April 25, 2019

**SUBJECT: Response to PA DEP and East Rockhill Township Comments  
Qualitative Geologic Survey Sampling Plan  
Rock Hill Quarry, SMP No. 7974SM1  
East Rockhill Township, Bucks County, PA  
EARTHRES Project No. 061003.051**

# Drawing D-1: Bench Face Mapping

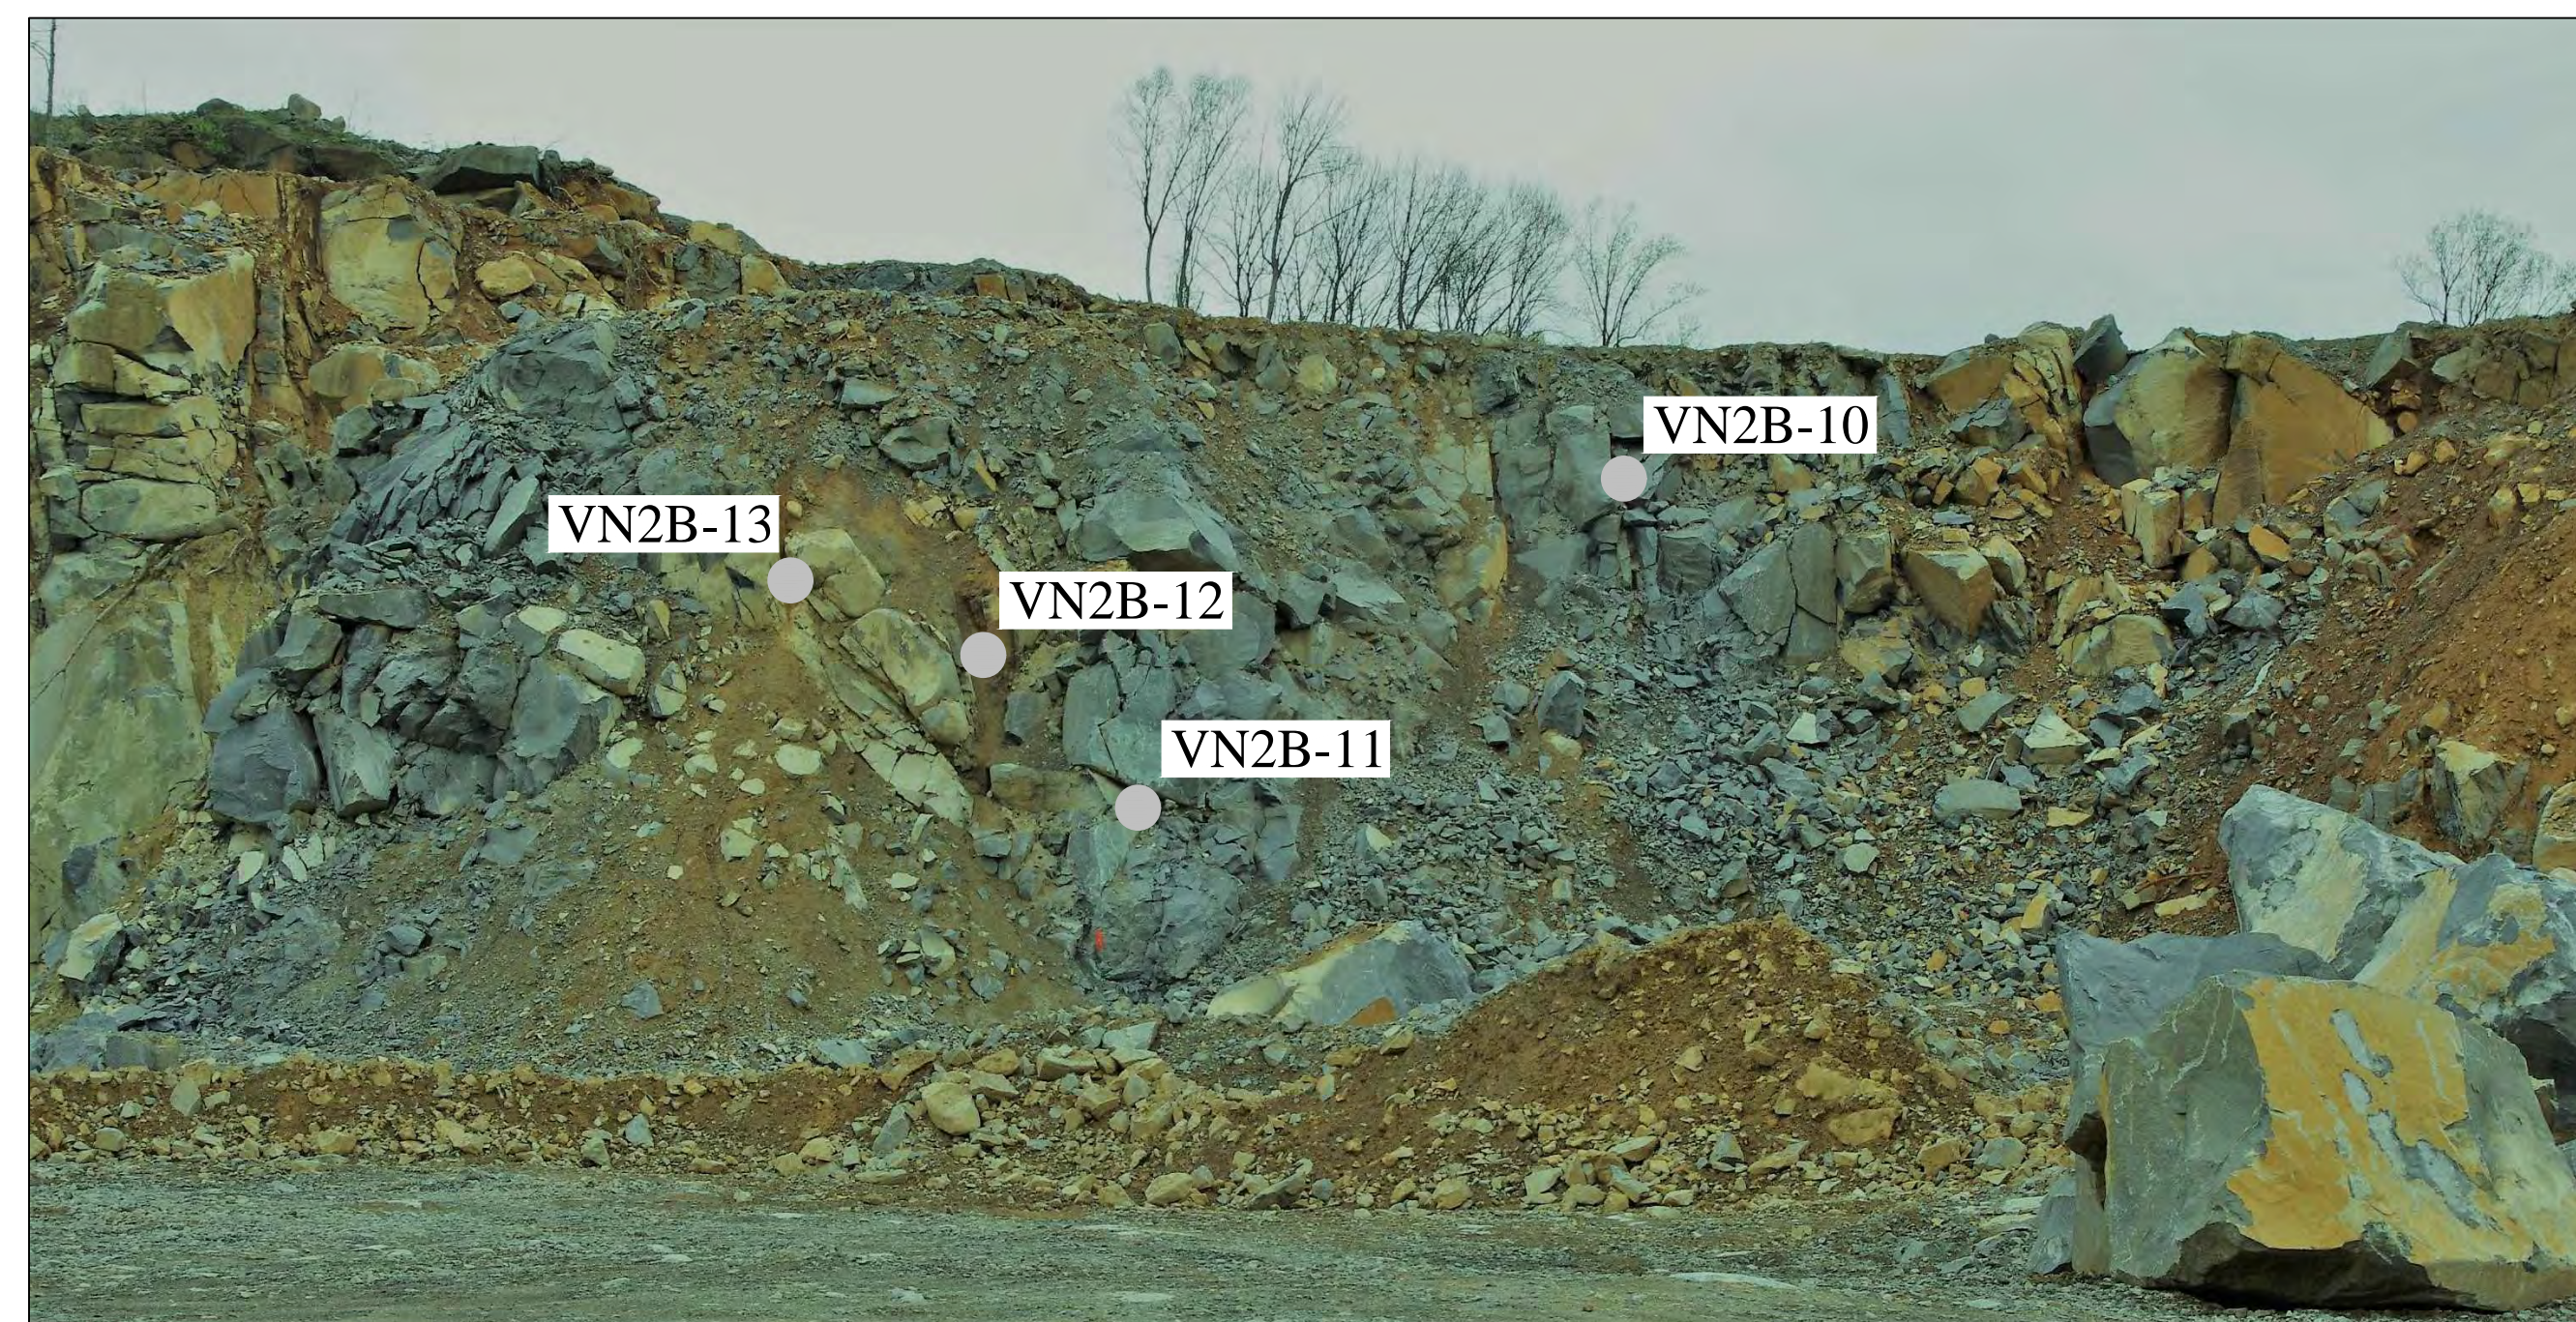
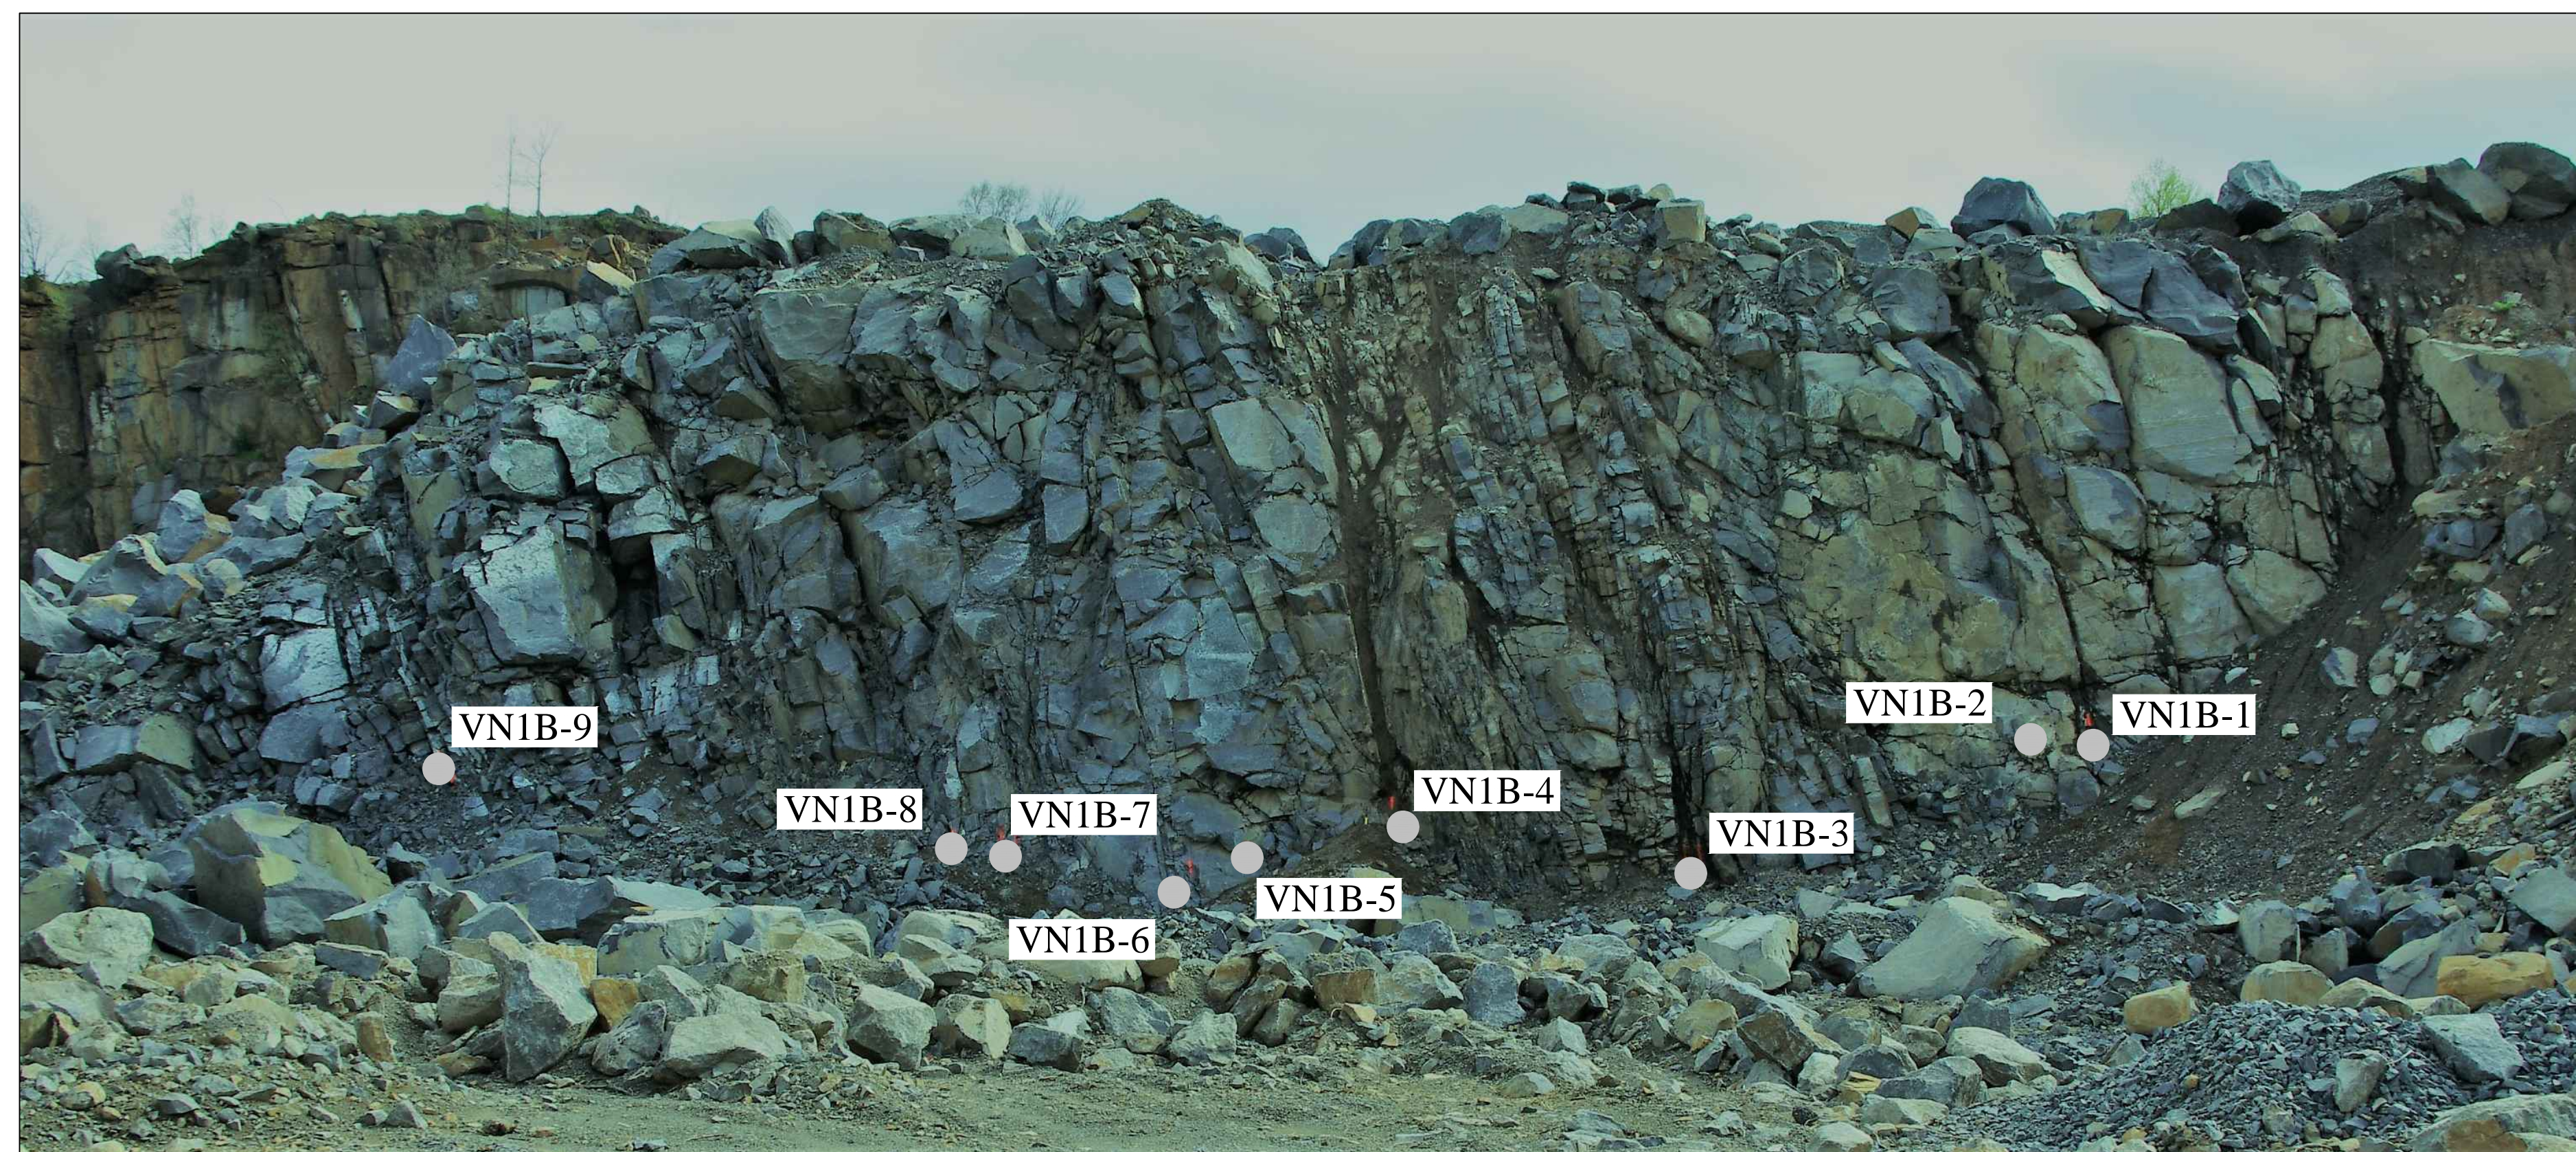
- 3) **Both the NSSGA Guide and the Aggregates Handbook encourage a proper mapping effort as part of the investigations described in these documents. The Department has notified Hanson during the December and February meetings and during other discussions that it expects the veins at the Rock Hill quarry to be mapped and described. To date, the Department has not received any information from Hanson regarding the mapping effort or its results. Results from a comprehensive mapping effort could effectively answer the Department's comments #1, #3 and #4 regarding the core drilling as well as East Rockhill Township's comment #4.**

*Please find the attached table that includes the geological data (i.e. strike, dip, and description) of the bench-face features found during the on-site mapping completed on April 22, 2019. The data was statistically analyzed using Rockworks software to determine the average strike and dip of the features. A stereonet plot of the data is attached and indicates an average strike of the vein features to be N45E, dipping steeply at 78 degrees SE. The average feature strike is in agreement with the regional strike direction indicated the QGSSP submitted on April 3, 2019. Also provided herein are photographs of the mapped features that are keyed to their locations on each bench (Drawing D-1: Bench Face Mapping). The data was further plotted in 3D using AutoCAD to evaluate feature trends with respect to the proposed drilling locations.*
